FED. ROAD DIST. NO.	STATE	PROJ. NO.	FISCAL YEAR	SHEET NO.	TOTAL SHEETS
HAWAII	HAW.	83G-01-03M	2005	ADD. 38	47

**PAVEMENT MARKING
 ϕ SIGNING PLAN**

KAMEHAMEHA HIGHWAY RESURFACING
 Kahiko Street to Pali Highway
 Project No. 83G-01-03M

Scale: 1" = 40' Date: Oct. 2004
SHEET No. T6 OF 8 SHEETS

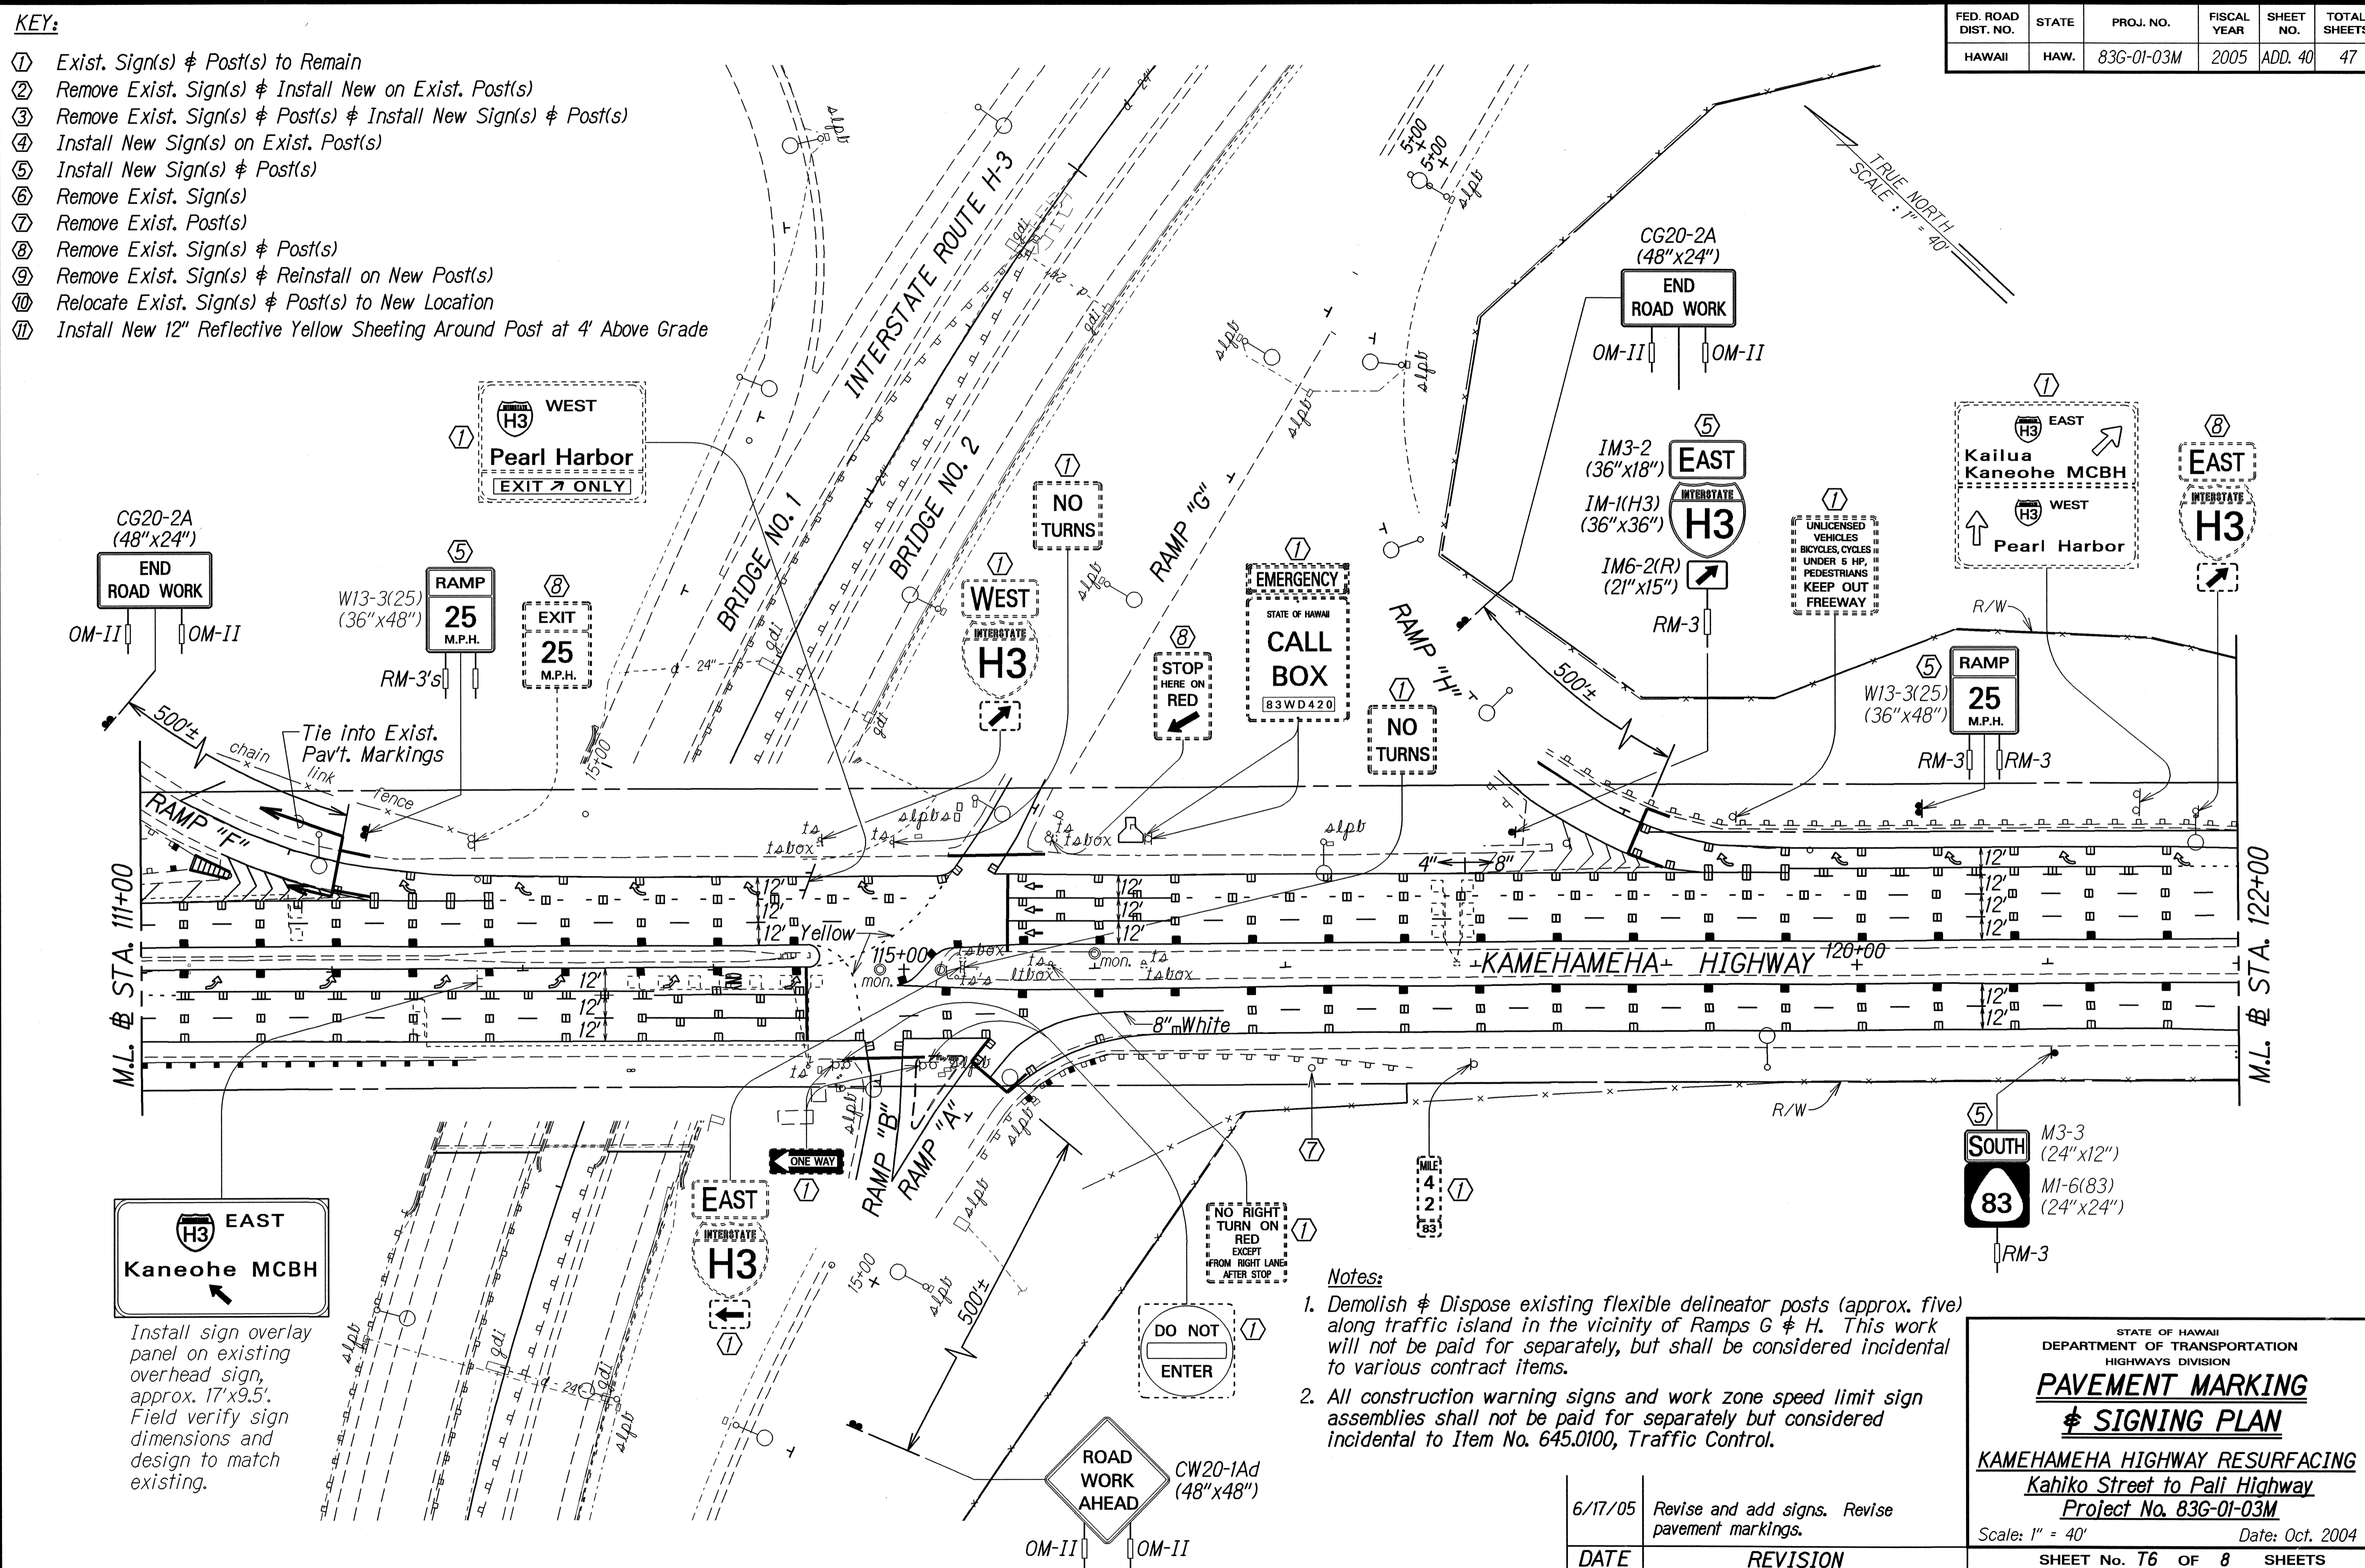
Install sign overlay panel on existing overhead sign, approx. 17"x9.5". Field verify sign dimensions and design to match existing.

DATE	REVISION
6/17/05	Revise and add signs. Revise pavement markings.

Scale: 1" = 40' Date: Oct. 2004
SHEET No. 77 OF 8 SHEETS

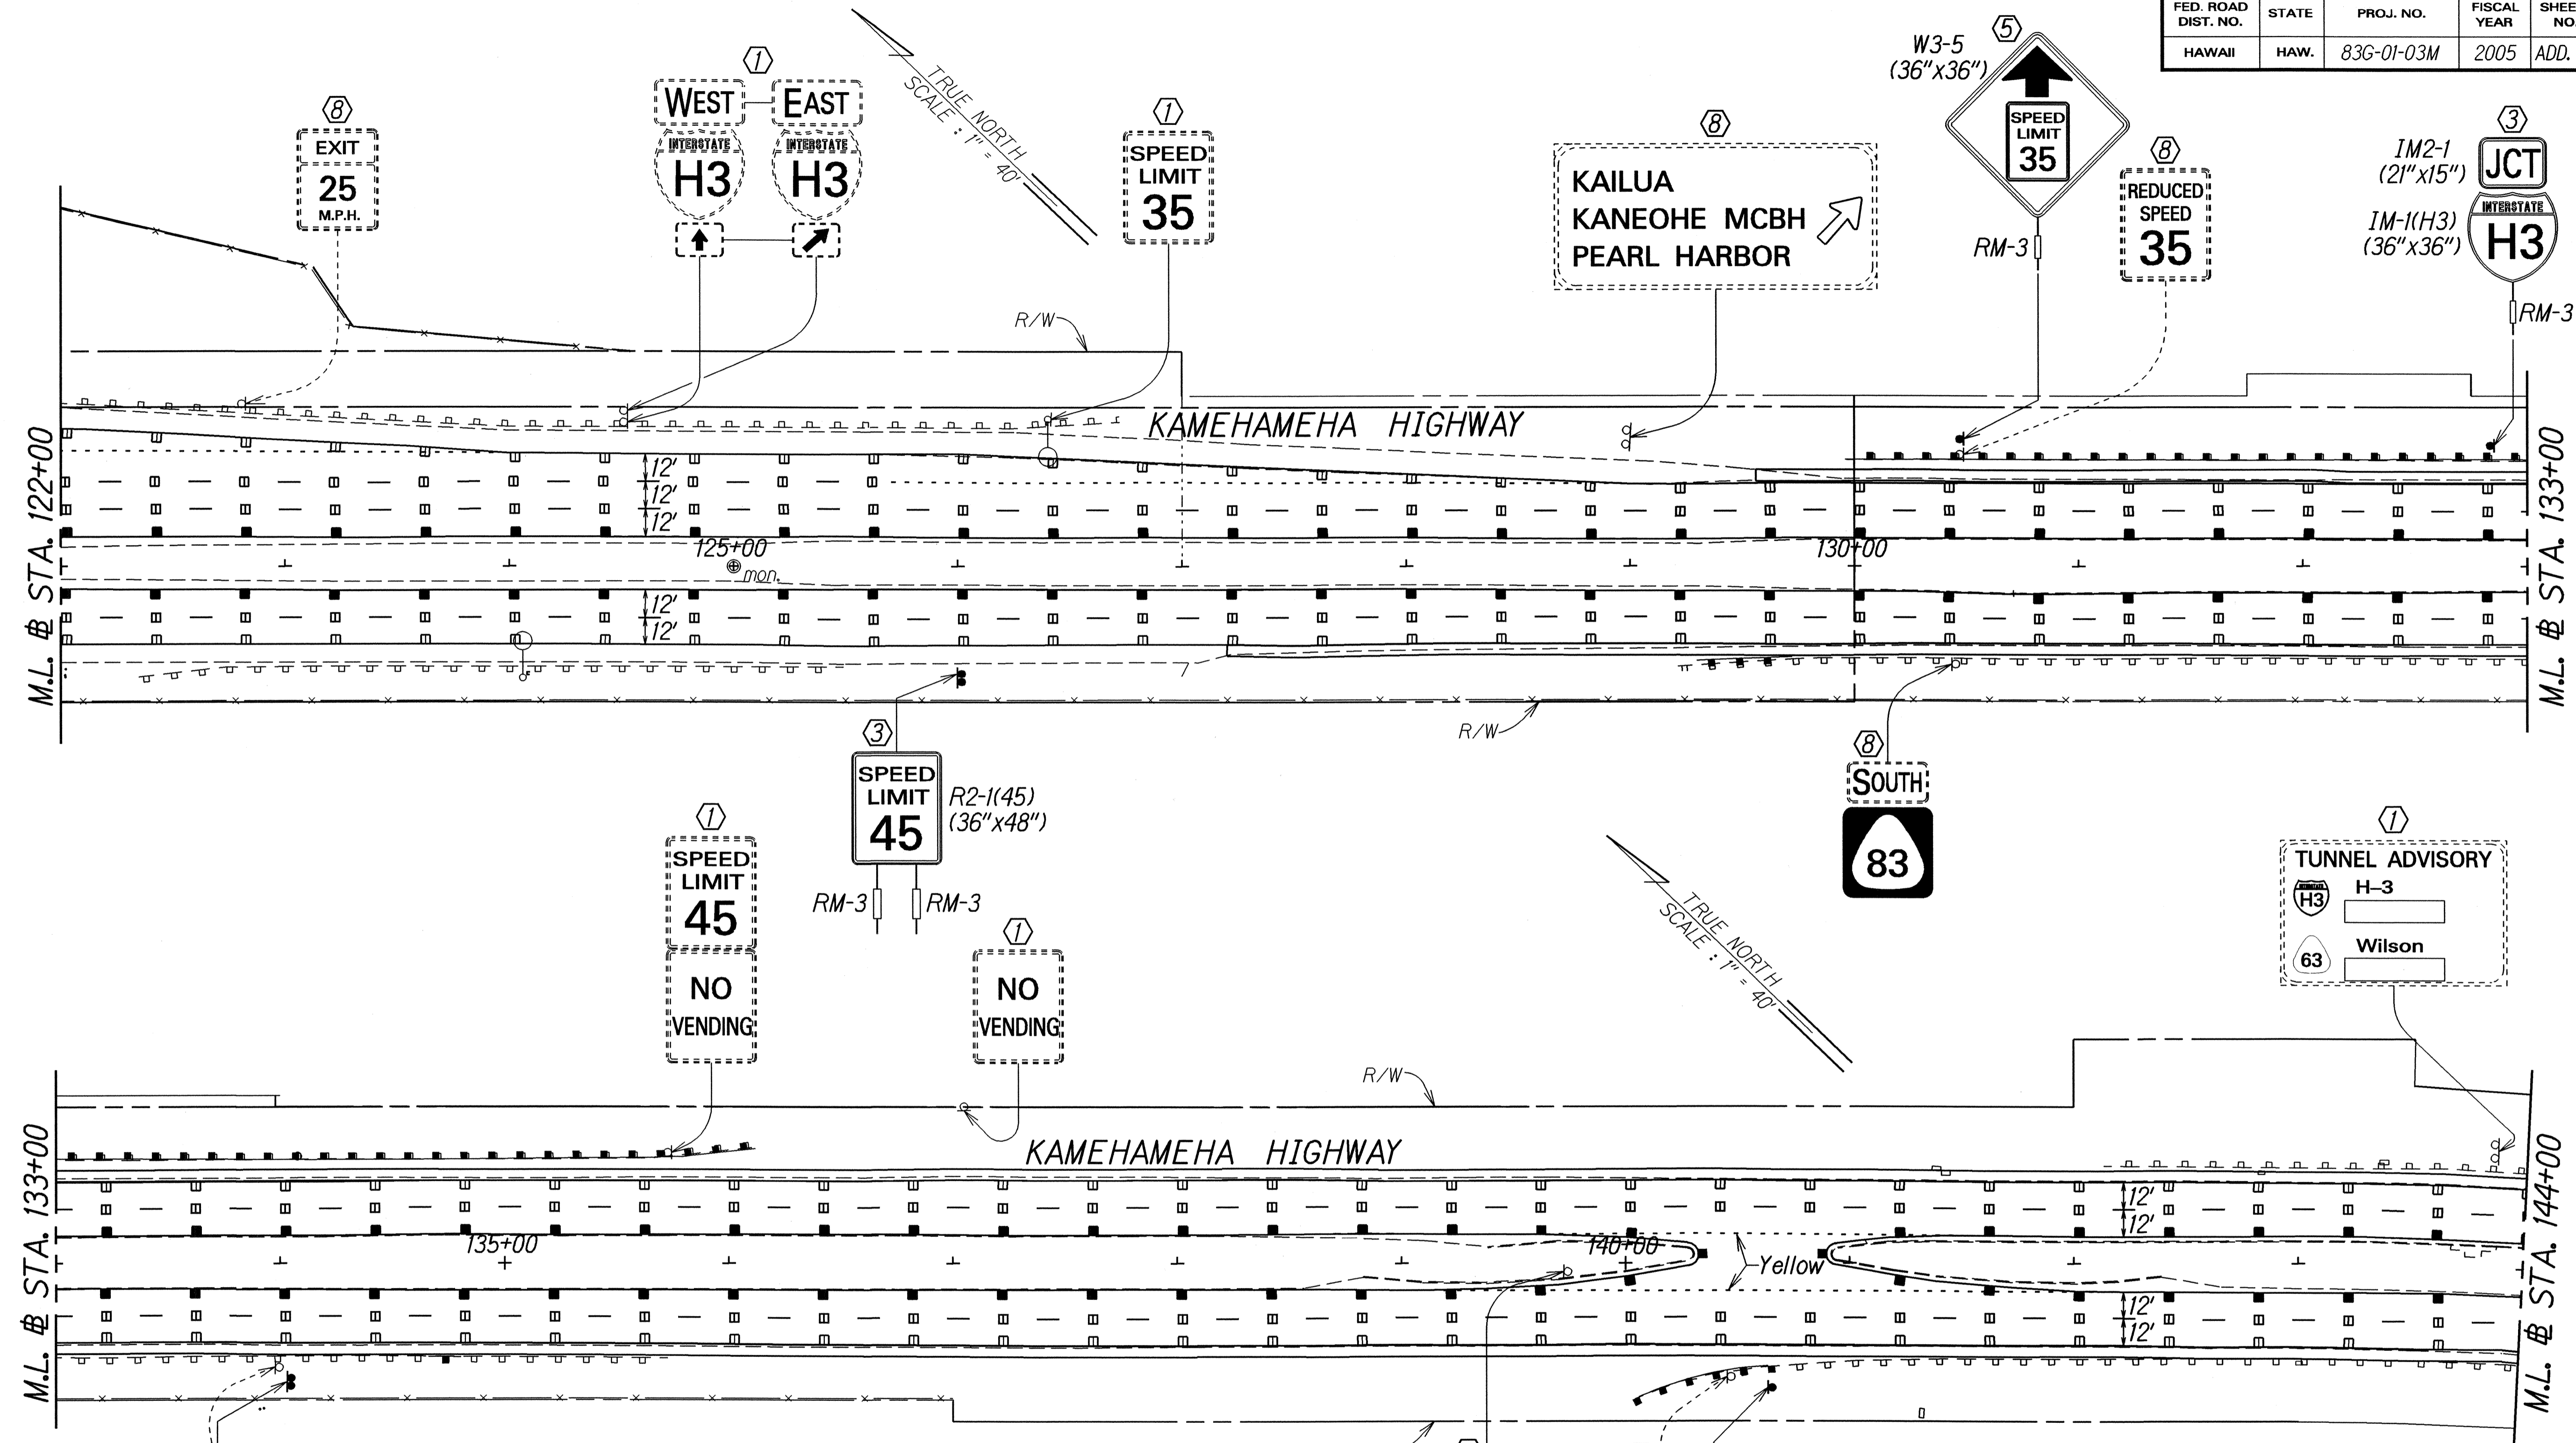
DATE	REVISION
6/17/05	Revise signs.

DATE	REVISION
6/17/05	Revise and add signs.
STATE OF HAWAII DEPARTMENT OF TRANSPORTATION HIGHWAYS DIVISION PAVEMENT MARKING & SIGNING PLAN KAMEHAMEHA HIGHWAY RESURFACING Kahiko Street to Pali Highway Project No. 83G-01-03M Scale: 1" = 40' Date: August 2003 SHEET No. T8 OF 8 SHEETS

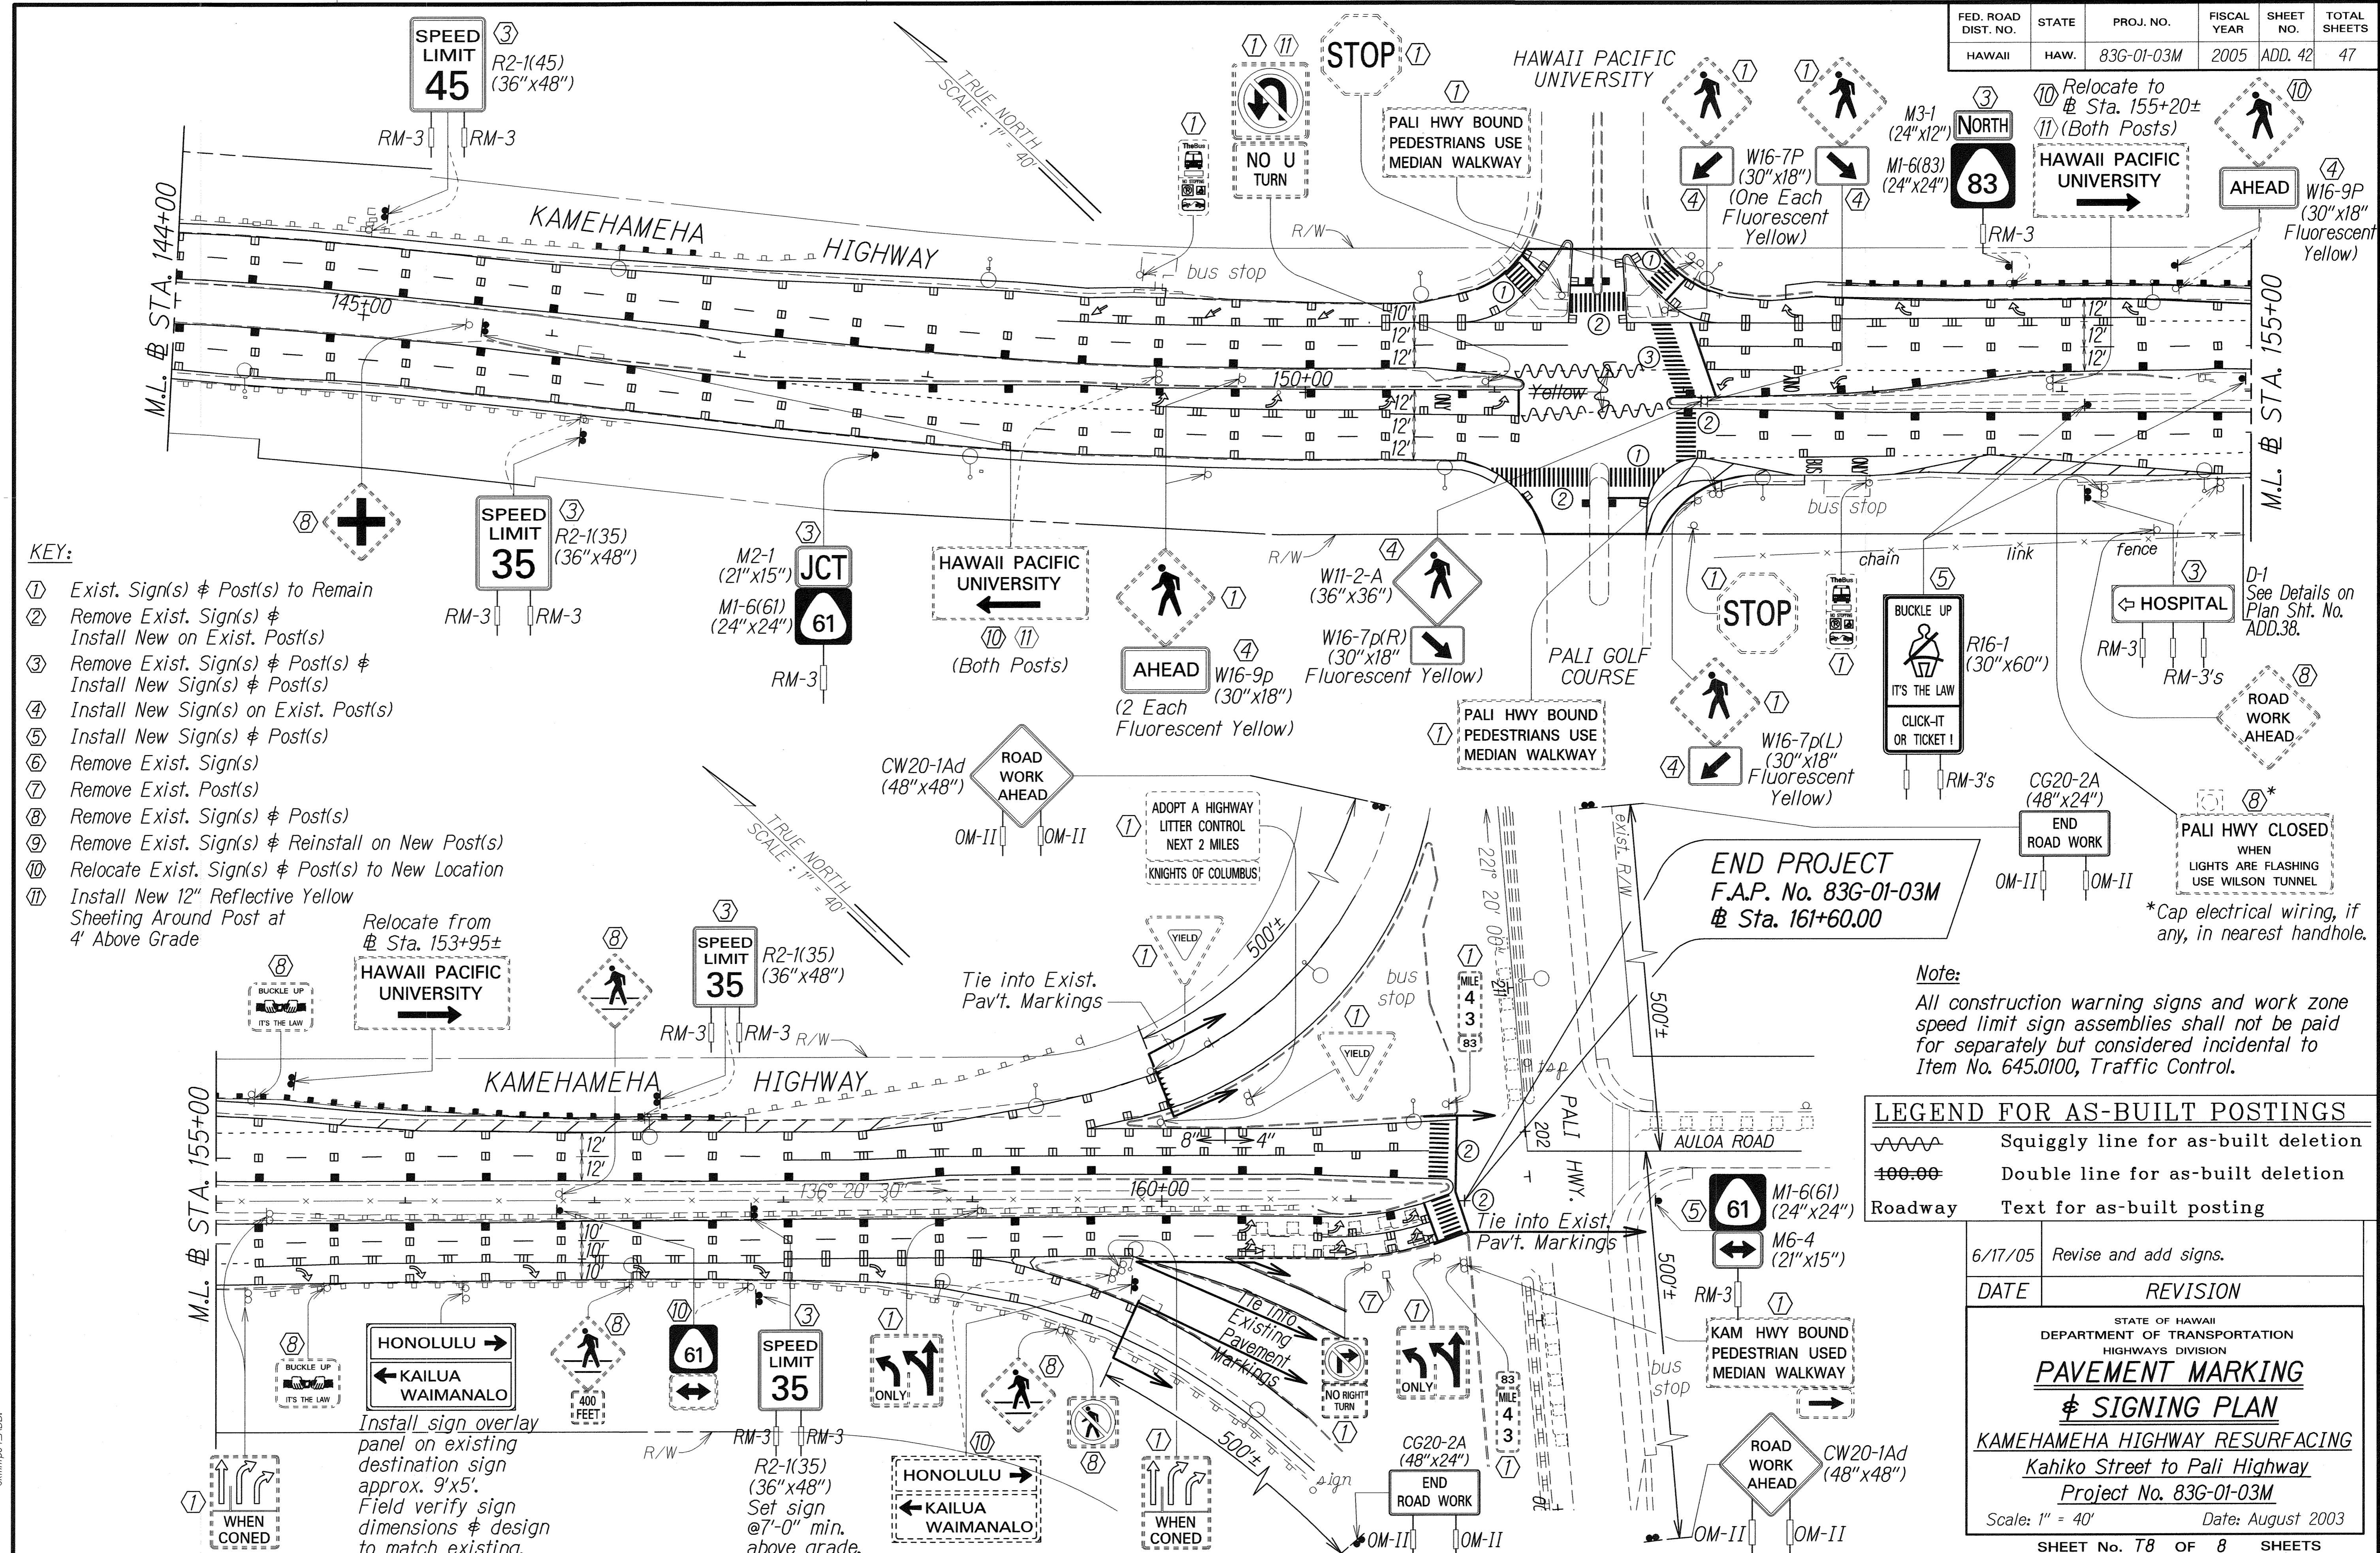
Install sign overlay panel on existing destination sign approx. 9'x5'. Field verify sign dimensions & design to match existing.
